# RENESAS TECHNICAL UPDATE

Product Category	System LSI		Document No.	TN-RIN-A015A/E	Rev.	1.00
Title	Ethernet MAC reception issue in case TCPIP accelerator enabled		Information Category	Technical Notification		
Applicable Product	Please refer to [1. Applicable Product] described below.	Lot No.	Reference Document	R-IN32M3 Series User's Manual: Peripheral Modules R-IN32M3-EC, R-IN32M3-CL Rev9.00 (R18UZ0007EJ0900)		
		All lot

Fig1: Flowchart of RX FIFO overflow processing task (In case of using HW-RTOS)

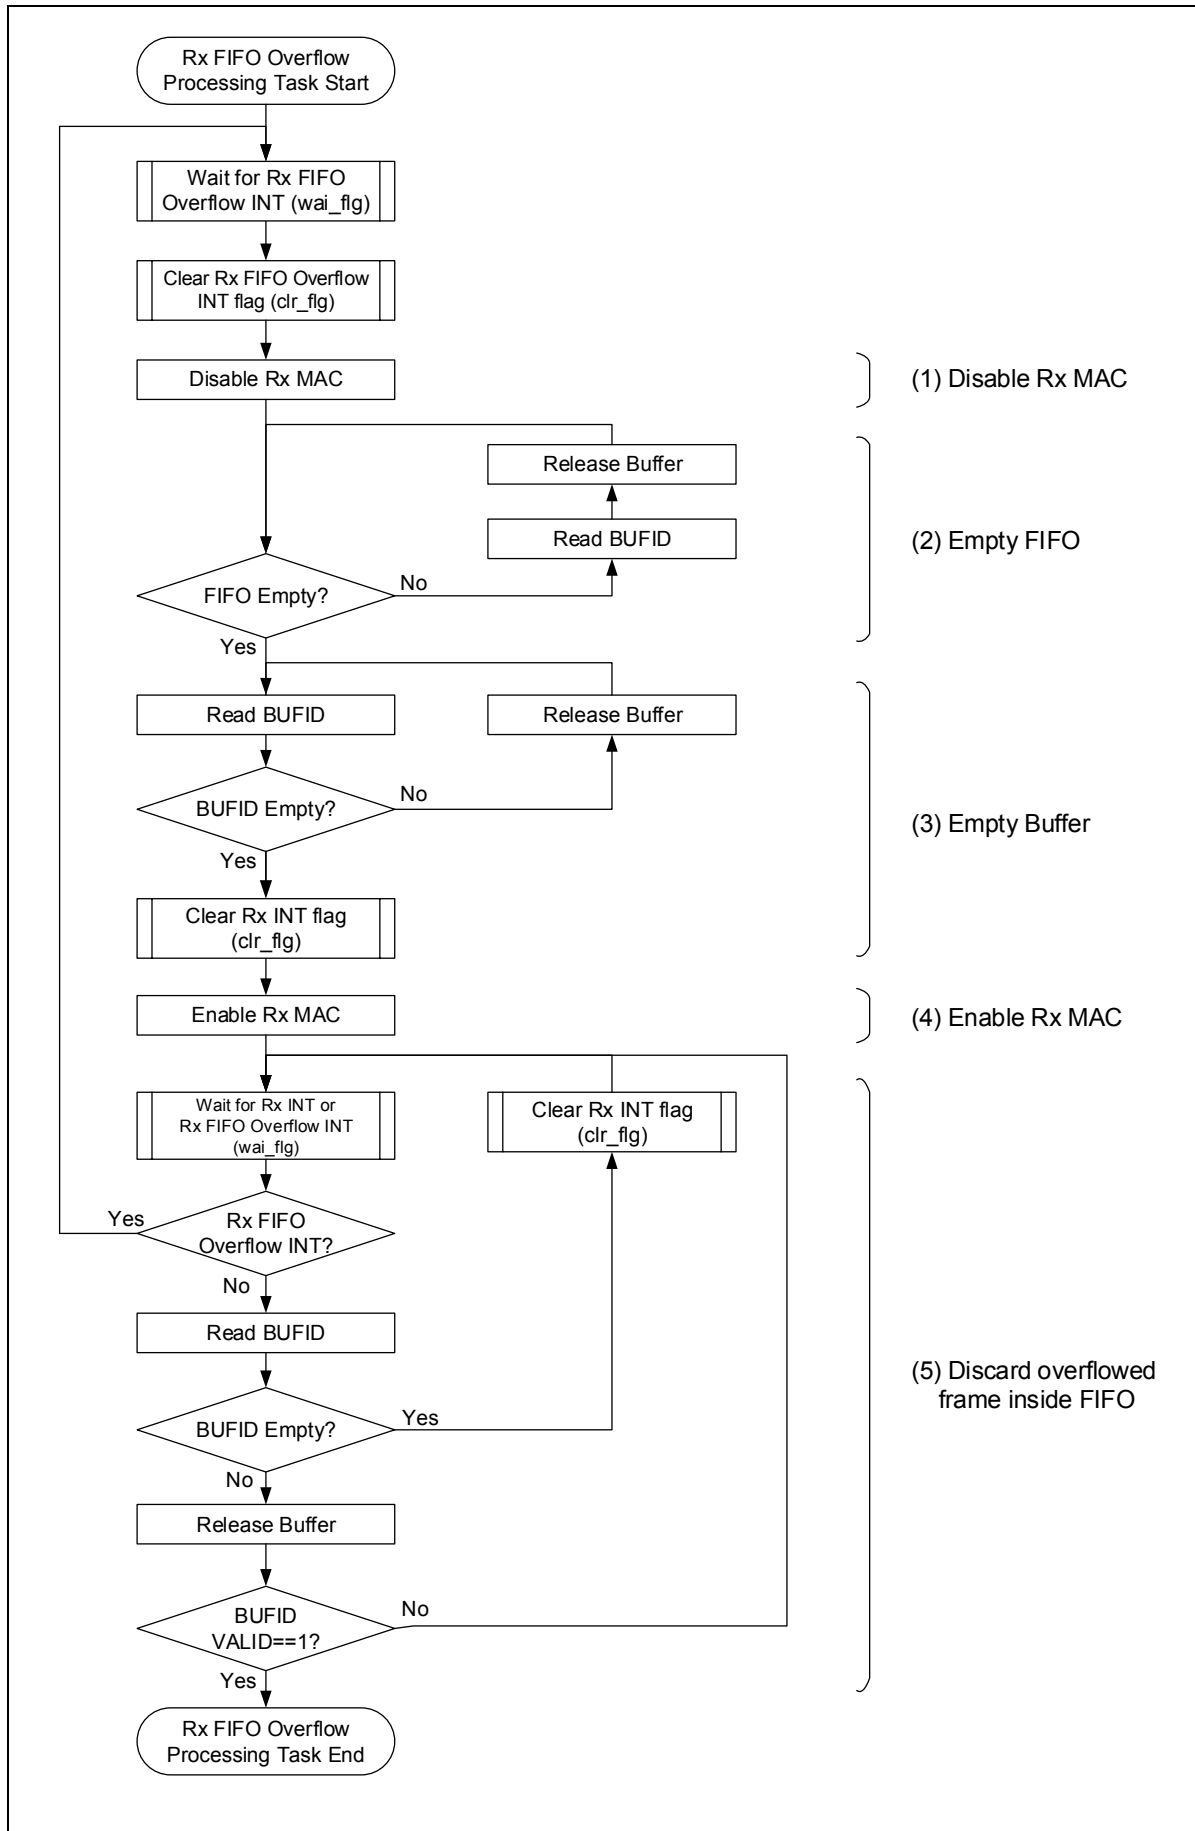
- It is possible that error information which is related to the previous error frame is included in frame information of normal reception frame.
- It is possible that abnormal frame which caused Rx FIFO overflow is regarded as normal frame because of illegal value is included in frame information

In case Rx FIFO overflow is occurred when Rx TCPIP accelerator is enabled.

- (A) Disable Rx TCPIP accelerator without padding insertion to MAC header. Specifically, clear bit0 of GMAC\_ACC register.
- (B) When Rx FIFO is overflowed, discard all frames left in Rx FIFO and Buffer RAM. Specifically, apply the following procedure;
  - (1) Disable Rx MAC.
  - (2) Discard all frames inside Rx FIFO.
  - (3) Discard all frames inside Buffer RAM.
  - (4) Enable Rx MAC.
  - (5) Discard at least one frame with BUFID VALID bit = 1. This is because FIFO empty state can be read even if the frame which caused FIFO overflow remains in the FIFO. Receive normal frame once and discard remained abnormal frame with it.

- ✓ Create overflow processing task with higher priority than one of reception processing task
- ✓ Start overflow task by HWISR combined with FIFO overflow interrupt
- ✓ Discard the abnormal frame remained in the FIFO by HWISR combined with reception interrupt

Fig 5: Flowchart of Reception processing

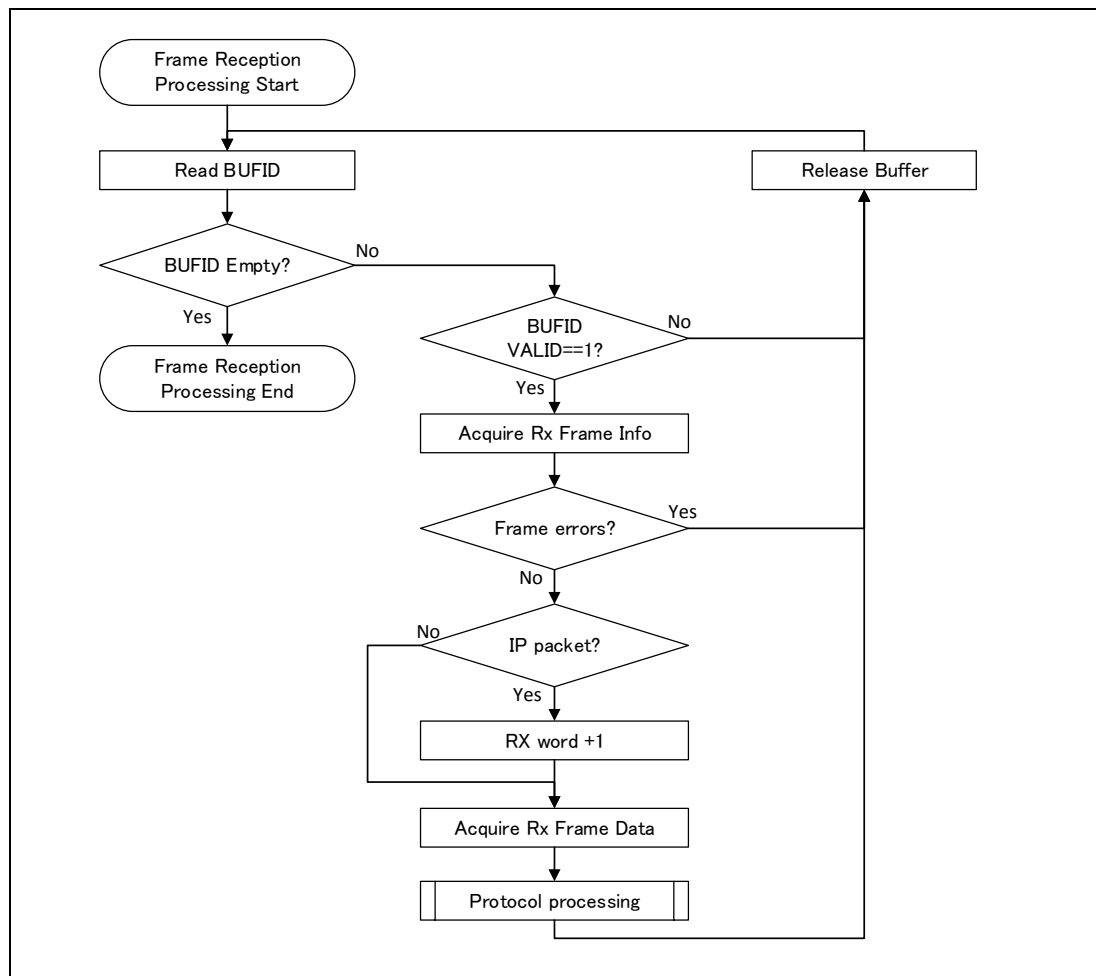
It is possible that reception word size (RX\_WORD[12:0]) in the frame information increases by 1 word (4 bytes) or decreases by 1 word compared with correct size. In case of decrease by 1 word, it is possible that RX\_WORD indicates the size which causes lack of IP packet. IP packet itself is NOT lacked.

- (A) RX TCPIP accelerator enabled
- (B) Reception frame meets all the following conditions;
  - (1) Frame size including FCS is more than 64 bytes.
  - (2) TCP/IP or UDP/IP packet is included.
  - (3) Padding (Trailer) is included between IP packet and FCS.

- (A) Disable Rx TCPIP accelerator. Specifically, clear bit0 or set bit2 of GMAC\_ACC register.
- (B) In order to avoid lack of the IP packet, increase reception word size by 1 and transfer the size to protocol stack. In the protocol stack, payload data should be extracted based on size of Total Length field in IP header and the rest data should be discarded. Fig 5 is the flowchart of this workaround.
